RE: **DRH16-00079**

### **DRH16-0007 / BVGC Parcel B, LLC**

Approval of sixty-percent (60%) construction drawings for the four-story, 600 stall parking structure with 10,000 square feet of office/retail space on the ground floor in a C-5DD (Central Business with Downtown Design Review) zone.

**Re: Submittal for 60% Construction Documents for Parking Garage Element of  
DRH16-00079  
SB Matter No. 23297.21**

NORTH ELEVATION

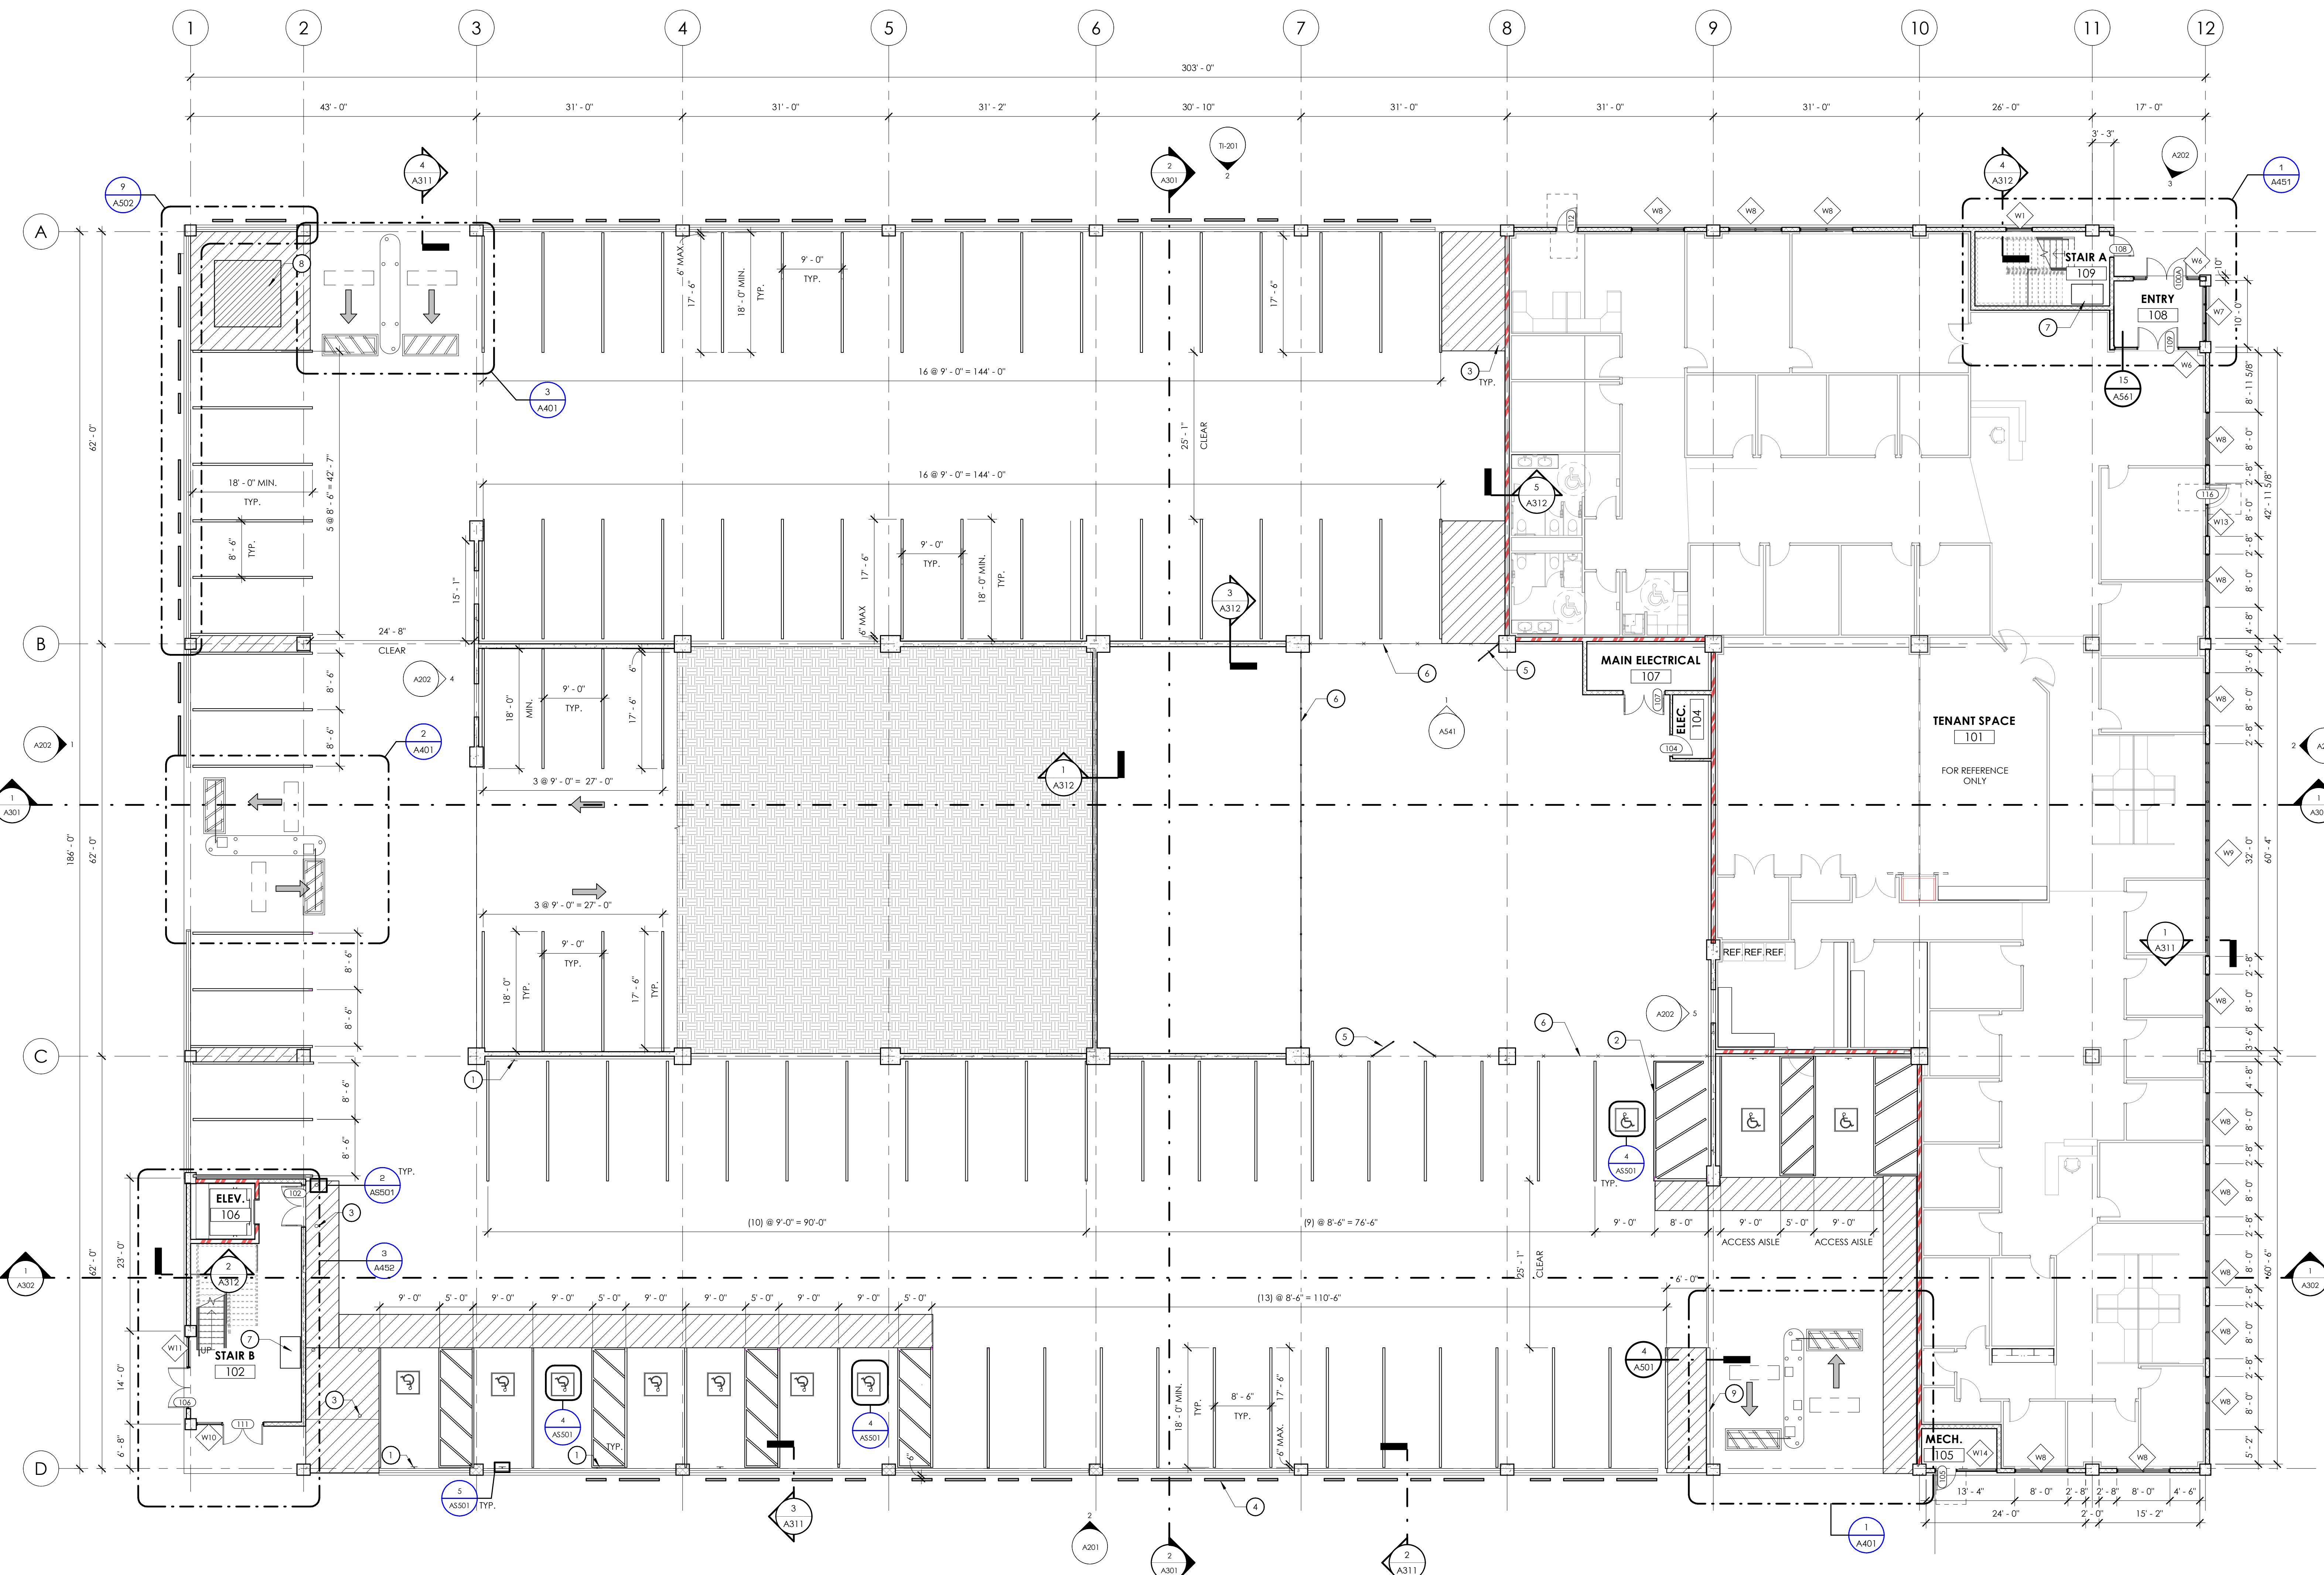
The building elevations submitted for the work session address the transparency of the screening and visibility of vehicles within the garage by increasing the number of perforated panels on the exterior of the structure, and increasing the thickness of the exposed concrete edge of each parking deck. This adds opacity and substance to the structure, reducing the open vision of vehicles while not creating a flat wall with no visual interest. There will be a total of 133 panels on the exterior of the building, placed on twenty bays opposed to the previous total of nine. The office/retail storefront on the 11<sup>th</sup> Street elevation has been reconfigured with more vertical orientation to the door and window placement, a simplified application of glazing in coordination with the floor plan, and the canopies have been lowered in conjunction with the increased parking deck thickness. Additionally, the tower element at the northeast corner has been modified to separate the entrances to the stairwell and elevator, providing two street level canopies and more glazing. The remaining

- The height of the exterior edge of the floors of the parking decks have been increased to 8" and additional structural elements on the east and west façades also provide additional screening of the underside of each deck on those façades, while providing greater horizontal definition especially on the 11<sup>th</sup> Street elevation;

- The increased depth of the structural elements on the eastern and western floor edges have been carried through and tied into the eastern and western stair and elevator towers at each level to provide horizontal interest;

- On the 11<sup>th</sup> Street façade at street level, windows, columns and awnings have been slightly reconfigured so that there is more vertical orientation of the storefront glass along 11<sup>th</sup> Street, slightly less random appearance of the door and window placement to better facilitate interior functionality, and the canopies have been modified to lower them slightly to offset the more substantial floor edge above;

- At the corner of 11<sup>th</sup> Street and Front Street, the entrances to the garage stairwell and elevator have been modified slightly so that they no longer share an entrance but instead have distinct entrances, with the upper floors cantilevering over the two separate entrances to provide a canopy for both entrances, with the result being that there is more glazing at the corner and greater space for pay stations at each floor level in the stairwell landings;

- Additional screening panels have been added to the garage for a total of 133 aluminum 3'-0" wide screening panels being placed on the exterior of the garage;

- The screening panels have been reconfigured so that instead of screening being placed over nine bays, we have expanded the screening to cover twenty bays to provide more coverage;

- The screening panels are typically spaced 2' apart, however we propose placing two panels immediately next to each other at various locations, so it appears that there are two sizes of panels being utilized 3'-0" and 6'-0" - the effect is that there would appear to be approximately forty five (45) large panels and forty three (43) small panels used on the various elevations;

- The screening panels will be configured so that the number of panels and spacing of the panels varies from bay to bay, and the number, space, and perceived size of panels are configured in a somewhat random manner;

- The screening panels will also be configured so that larger openings in the screening along the various elevations identify the location of the access points to the garage for both pedestrians and vehicles to reinforce the entrance locations;

- The screening panels have been oriented to provide the greatest screening to views from 11<sup>th</sup> Street and Front Street on the north and east elevations, providing the greatest visual screening to vehicles that are stopped at 11<sup>th</sup> Street and headed onto the Connector, recognizing that the improvements on the western and southern portion of

- The sheer walls that were formerly on the exterior of the garage have been relocated to the interior which should make the perimeter less massive and provide greater opportunity for visual interest with the metal panels.
